**STAFF REPORT** 12-11-2019 MEETING  
**APPLICATION NUMBER:**19-6586  
**ADDRESS:** 2001 PARK AVENUE  
**HISTORIC DISTRICT:** GRAND CIRCUS PARK  
**APPLICANT:** BRIAN REBAIN  
**DATE OF COMPLETE APPLICATION:** 12/4/2019  
**DATE OF STAFF SITE VISIT:** 12/4/2019

**SCOPE:** REHAB BUILDING

**ROOF AND PENTHOUSE PLAN**  
SCALE: 1/8" = 1'-0"

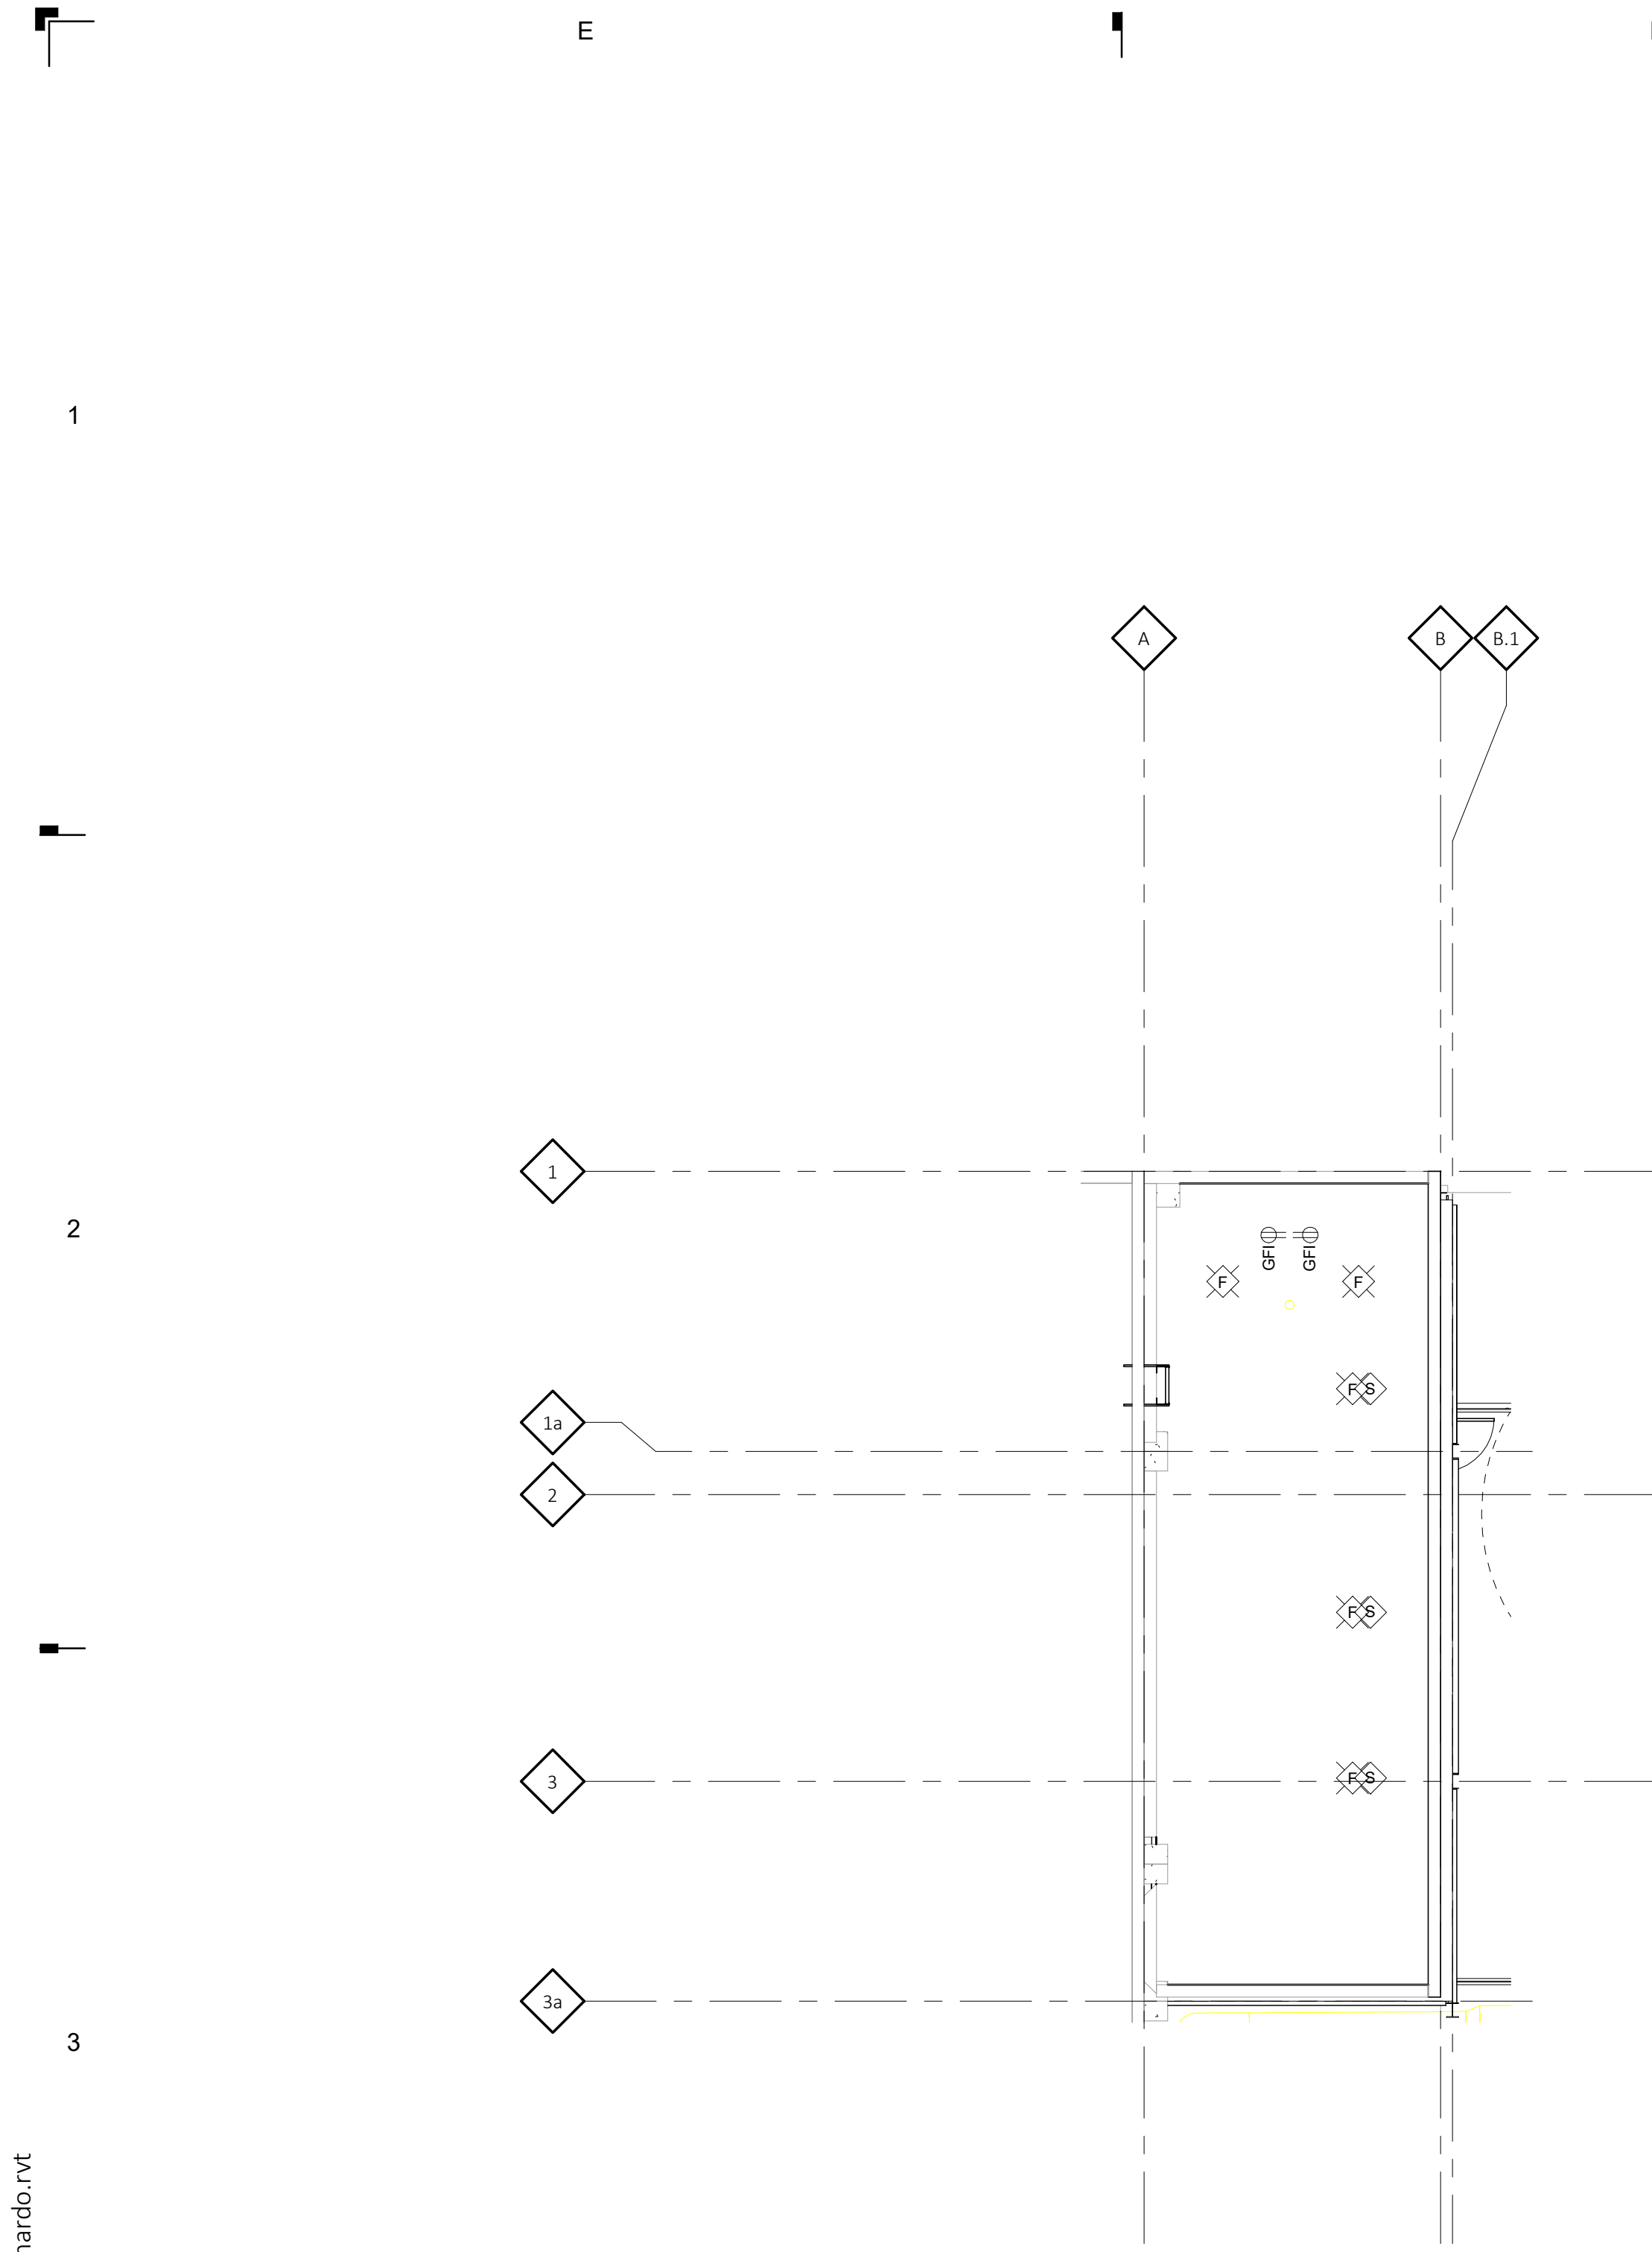
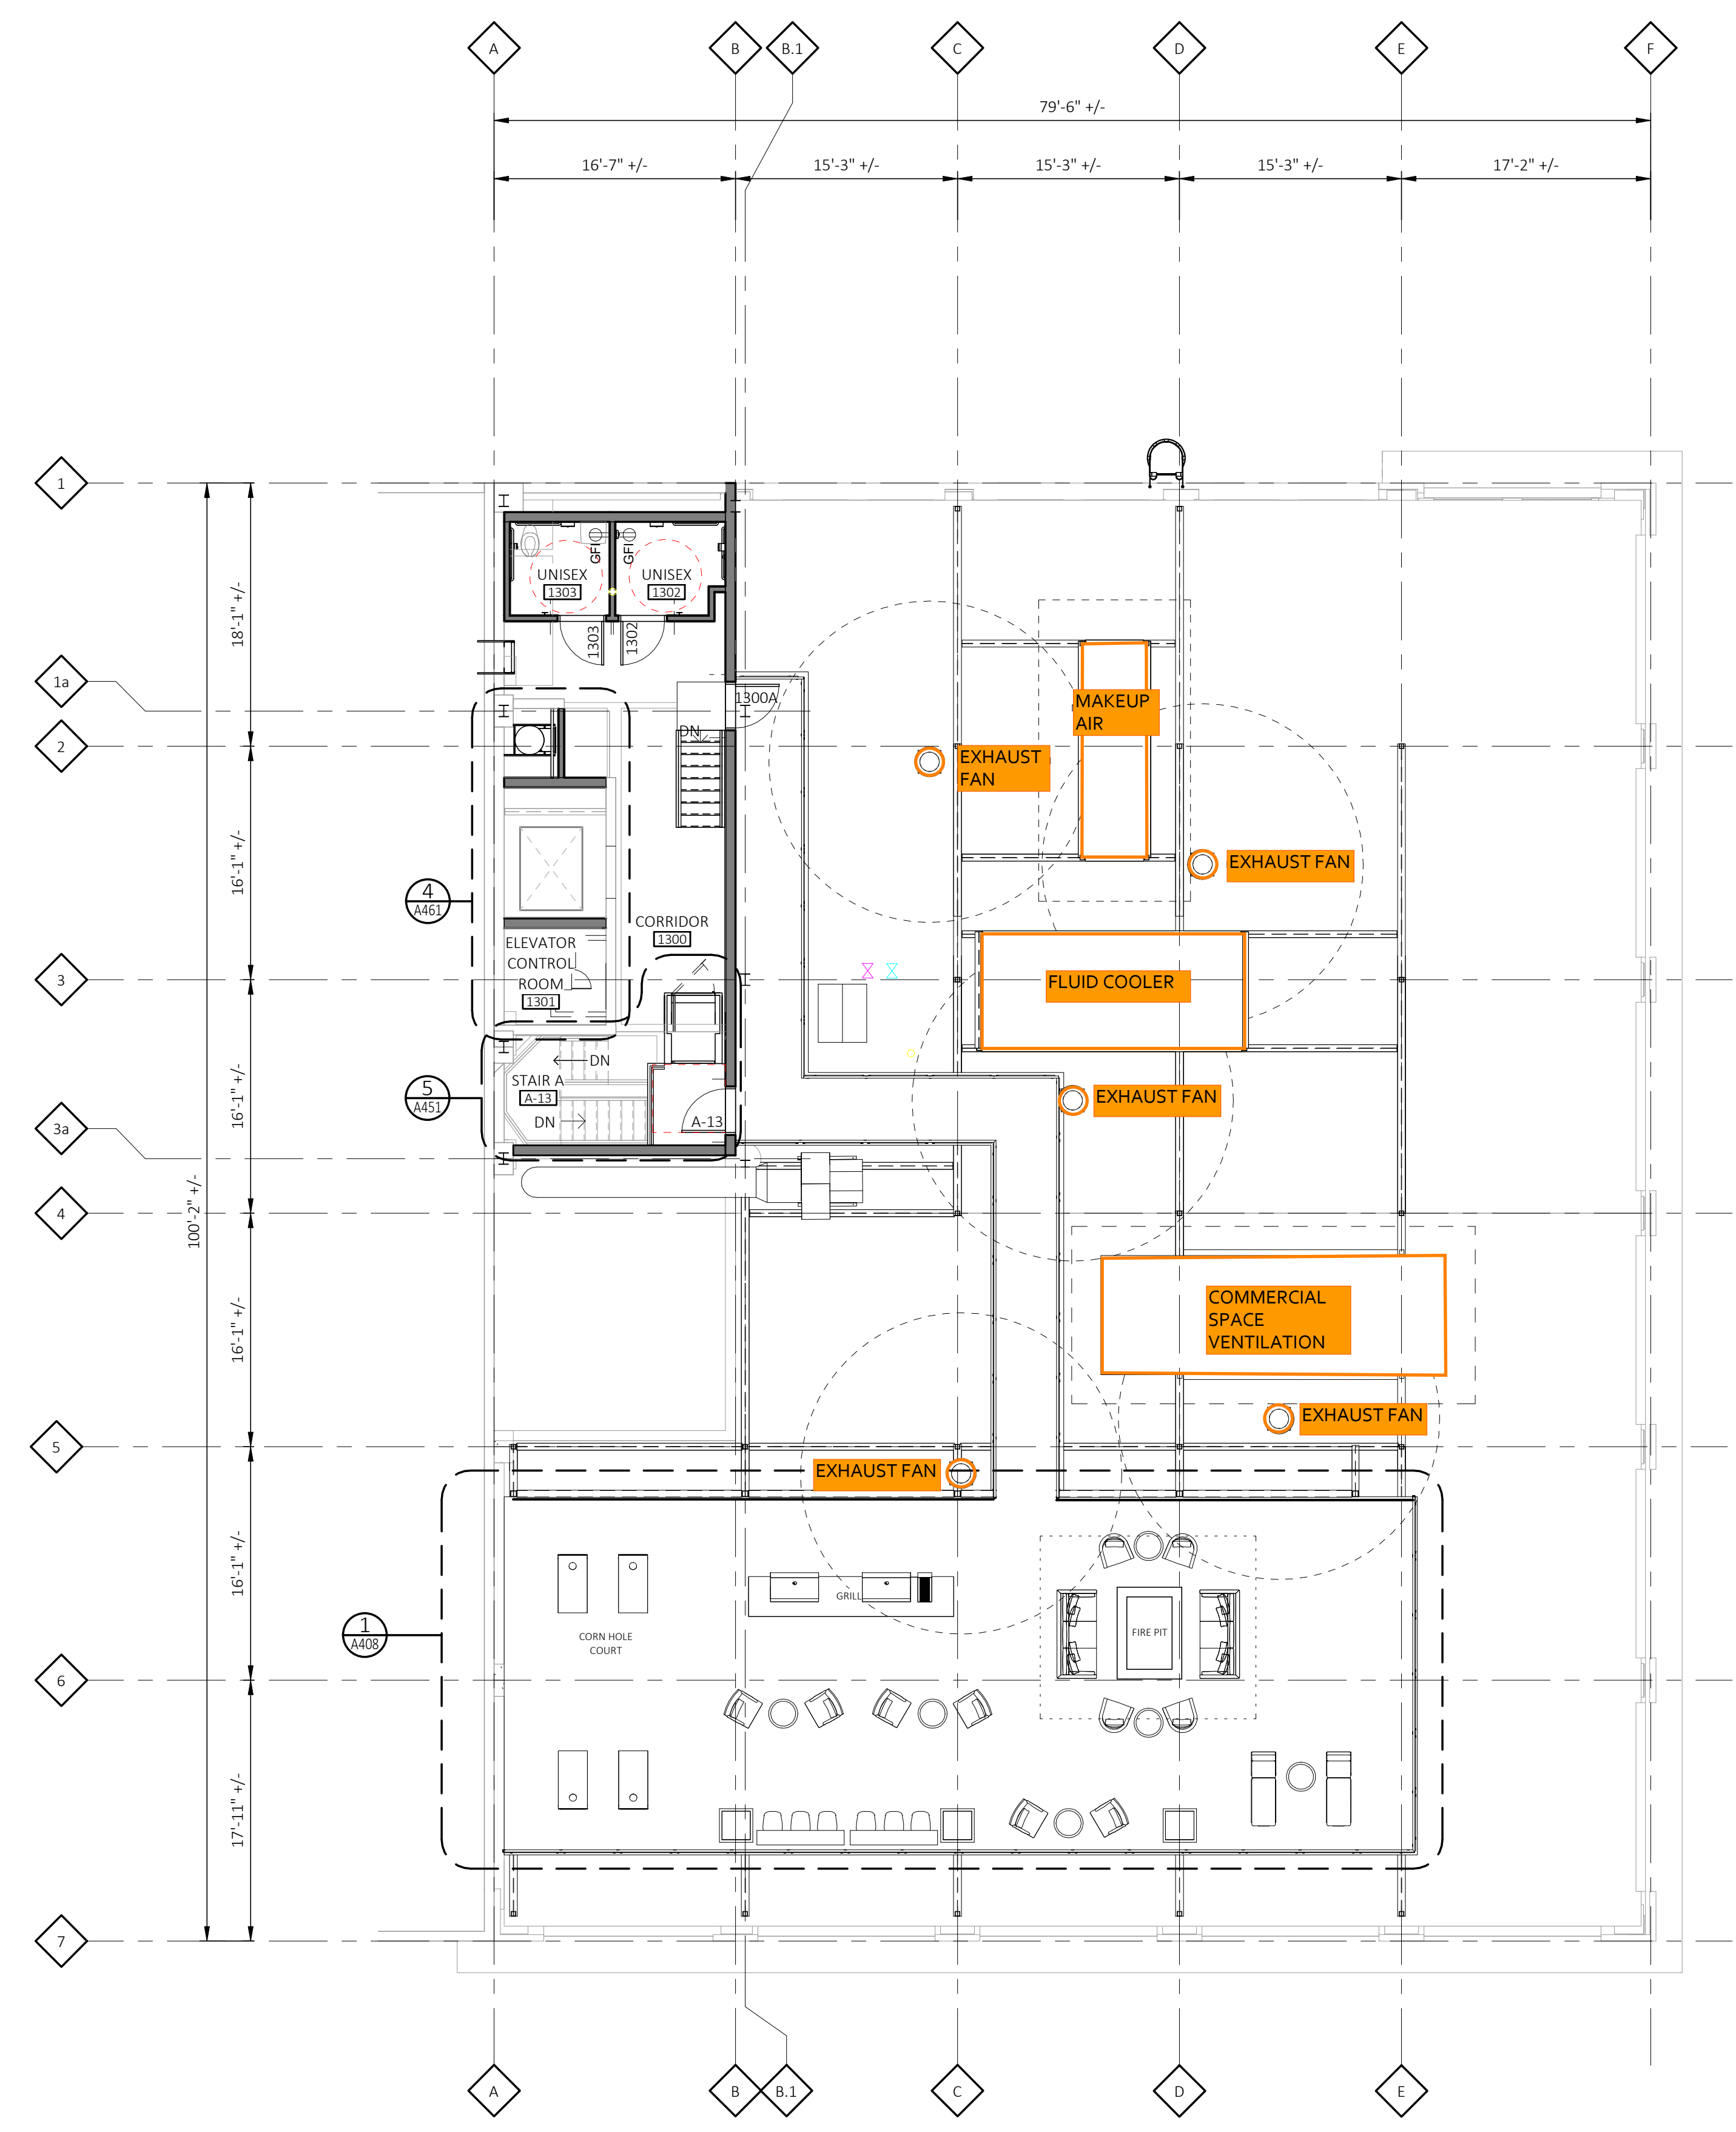
- A roof deck will be added at the south side and will be accessed via the penthouse. A glass guardrail with black supports will encompass the roof deck and walkway.
- New mechanical equipment will be added to the north/middle side of the roof and a black metal perforated screen wall will be added in between the roof deck and the mechanical units.
